Staff Report

Project Name: Nevada Street Townhomes

Case Number: PDO17-0005

Application type: Planned Development Overlay

Figure 1

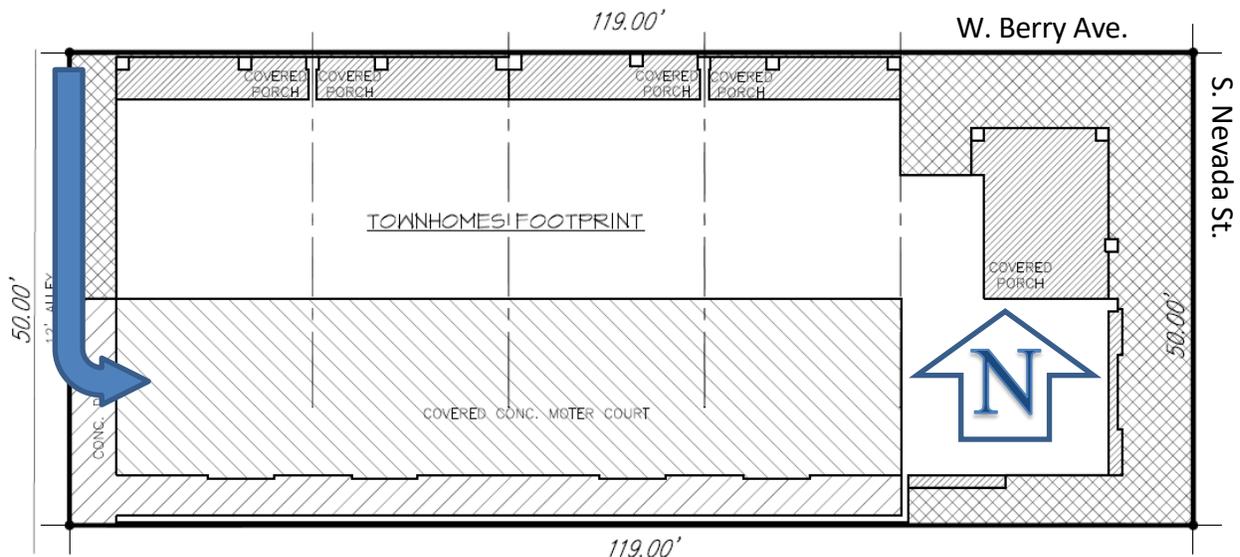
The elevation above in figure 1 shows the conceptual northern elevation along W. Berry Ave. The dashed, vertical lines delineate the dwelling units. Four of the five dwelling units will have front doors on W. Berry Ave. and the fifth dwelling on the far left (east) will have a front door that faces S. Nevada St. Vehicular access to the dwelling units is provided from W. Berry Ave. through the alley and enters the property from the west as shown by the blue arrow in figure 2 below. The individual garages are on the first floor of each dwelling and provide one parking space for each dwelling that faces W. Berry Ave. and two parking spaces for the easternmost dwelling that faces S.

Nevada St. The garages exit into a covered motor court and the second and third stories of the dwellings extend over this covered motor court.

The applicant is proposing to supply additional parking in two of the units (units B and D) through the incorporation of a vehicle lift system, which allows parked vehicles to be stacked one on top of another. The conceptual plans show six off-street parking spaces and the applicant plans to have vehicle lifts above two of the spaces, for a total of eight off-street parking spaces, which meets LCC requirements.

Figure 2

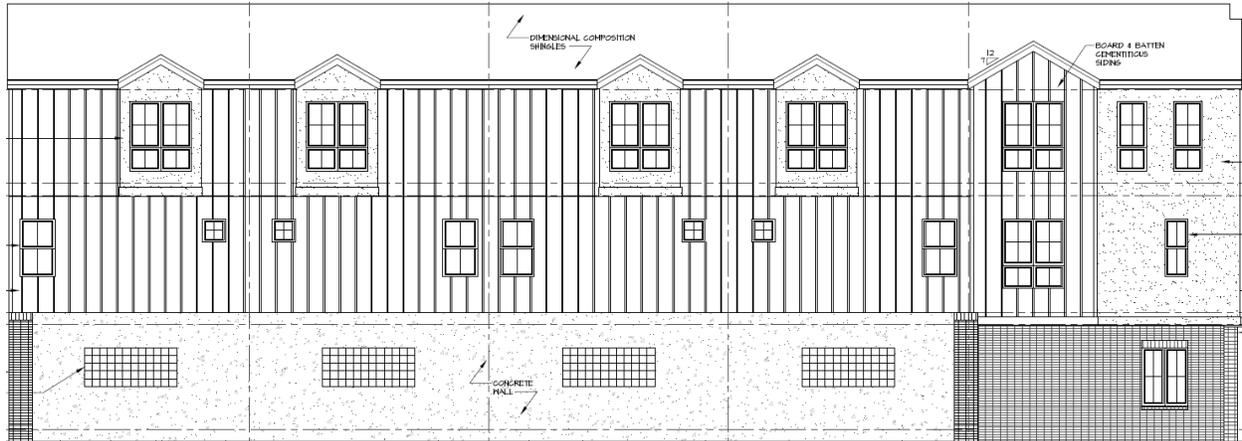
Because the majority of the units have front doors that face W. Berry Ave., the northern lot line is the front, the southern lot line is the rear, and the eastern and western lot lines are sides. The application seeks to establish lesser setbacks from all lot lines, with the front setback being 0.17 feet and rear setback being 0.33 feet. This is a significant reduction from the 20-foot front and rear setbacks that are required in the underlying R-5 zone district. The reduced rear setback at the south property line would result in a building that is 5.33 feet from the existing single family residence on the adjacent property to the south. Additionally, the design and site characteristics included in the PDO do not include any heightened level of design on this elevation and would allow for this southern façade to include a 10-foot concrete wall as shown on the conceptual southern elevation in Figure 3, on the following page. This exemplifies the insufficiencies in the proposed design and site characteristics that would be established through this PDO. These design and site characteristics do not establish design requirements or standards that extend substantially beyond the minimal levels already required in the LDDSG.

The application also includes a reduction in unobstructed open space in the underlying R-5 zone district from 25% to 15.6%. Open space on residential properties serves several purposes including aesthetics and functional buffering between properties and uses. A common unobstructed open space would be provided primarily at the western end of the subject property, with a narrow band of landscaping on the east end adjacent to the alley. With the proposed

setbacks, no landscaping or buffering can be accommodated along the southern property line between the proposed multi-family development and the existing single family residence that would be most significantly impacted by the development of the subject property.

Figure 3

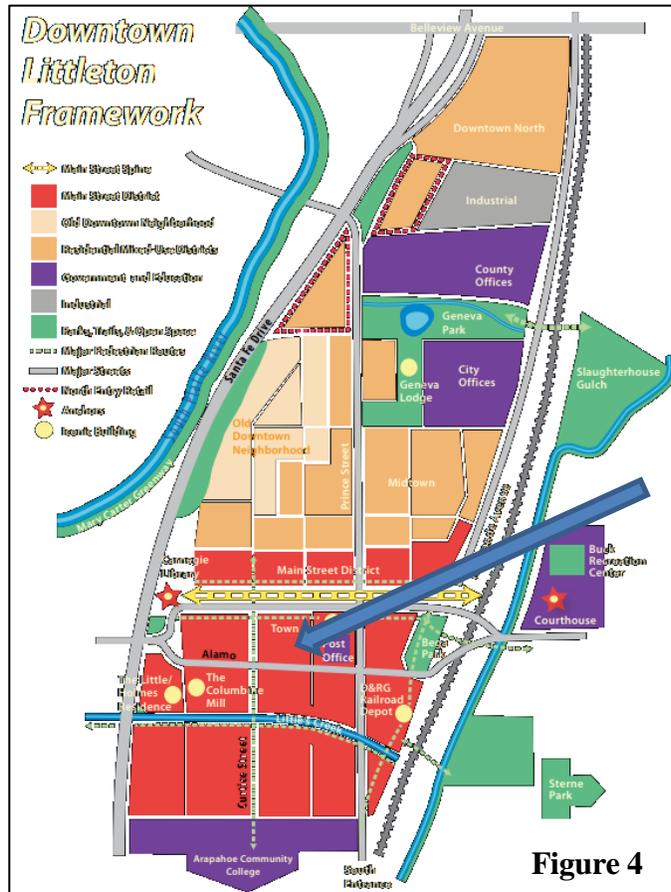
The final variation from the R-5 zone district requested through this PDO would increase the maximum height. The proposed PDO would establish a new maximum height of 38 feet on the subject property. This would be 26% higher than the 30-foot maximum height in the underlying R-5 zoning district. The primary roof form would be a gabled roof as required by the LDDSG and the PDO’s proposed design and site characteristics. Staff does not find that the design and site characteristics to demonstrate the special attention to creative, high quality design that would be needed to establish an increased height without impairing the intent of the land use code as required by LCC Section 10-9-5 and is recommending denial.
